Subject: Safety Recall BLC (Interim B2C) - Interim Notice
Certain 2004 - Early 2007 Model Year RX 330, RX 350 and RX 400h Vehicles
Driver's Side Floor Carpet Cover and Retention Clip

**Certain 2004 – 2007 Model Year RX330/350/400h
Floor Carpet Cover and Retention Clip
Safety Recall Notice (Interim Notice)**

Safety Recall BLC - Q&A
Certain 2004 - Early 2007 Model Year RX 330/350/400h
Driver's Side Floor Carpet Cover and Retention Clips

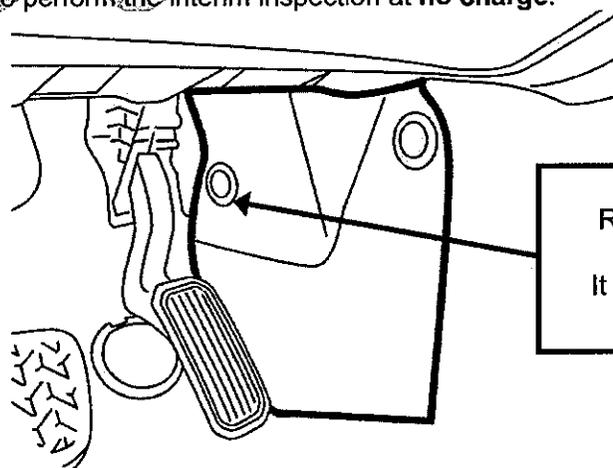
In certain 2004 through 2007 model year RX330/350/400h vehicles, if the forward retention clip used to secure the driver's side Floor Carpet Cover, which is located in front of the center console, is not installed properly, the cover may lean toward the accelerator pedal and interfere with the accelerator pedal arm. If this occurs, the accelerator pedal may temporarily become stuck in a partially depressed position rather than return to the idle position. An accelerator pedal temporarily stuck in a partially depressed position may increase the risk of a crash.

Once the remedy parts are available, Lexus will replace the Floor Carpet Cover with one of a different shape as well as the forward and rear retention clips. ***Lexus will send a second owner notification letter when the replacement parts are ready and preparations are complete.***

Verify that the Forward Retention Clip is properly installed. It should not be missing or loose.

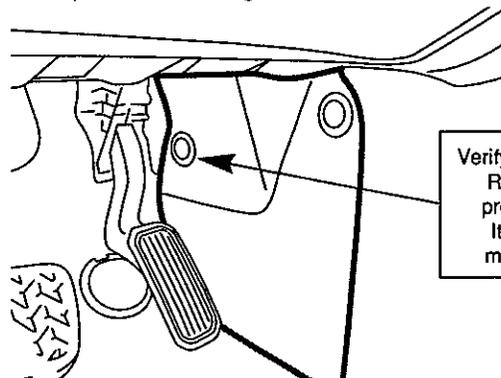
In 2004 through early 2007 model year RX330/350/400h vehicles, if the forward retention clip used to secure the driver's side Floor Carpet Cover, which is located in front of the center console, is not installed properly, the cover may lean toward the accelerator pedal and interfere with the accelerator pedal arm. If this occurs, the accelerator pedal may temporarily become stuck in a partially depressed position rather than return to the idle position. An accelerator pedal temporarily stuck in a partially depressed position may increase the risk of a crash.

Once the remedy parts are available, Lexus will replace the Floor Carpet Cover with one of a different shape as well as the forward and rear retention clips. *Lexus will send a second owner notification when the replacement parts are ready and preparations are complete.*

Verify that the Forward Retention Clip is properly installed. It should not be missing or loose.

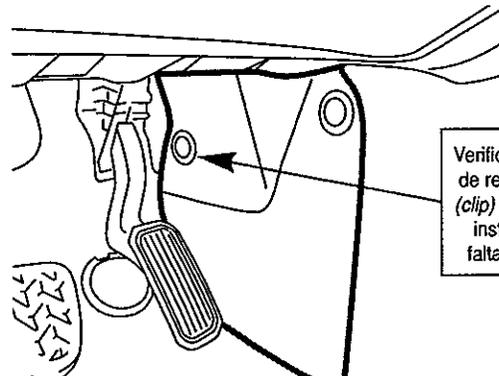
En ciertos vehículos RX330/350/400h, modelos 2004 a principios de 2007, si no estuviera instalado debidamente el gancho de retención (clip) delantero, que se utiliza para fijar la cubierta de la alfombra del piso del lado del conductor—situada frente a la consola central—la cubierta puede inclinarse hacia el pedal del acelerador e interferir con el brazo del mismo. Si esto sucede, el pedal del acelerador podría atascarse temporalmente en una posición parcialmente deprimida, en lugar de volver a la posición neutra. El atascamiento temporal del pedal del acelerador en una posición parcialmente deprimida podría aumentar el riesgo de que se produzca un choque.

Una vez que estén disponibles las partes para implementar la solución, Lexus reemplazará la cubierta de la alfombra del piso por otra que tenga una forma diferente, así como también, los ganchos de retención (clips) delantero y trasero. **Lexus enviará una segunda carta de notificación al propietario cuando estén listas las partes de reemplazo y se hayan completado los preparativos.**

Venifique que el gancho de retención delantero (clip) esté debidamente instalado. No debe faltar ni estar suelto.
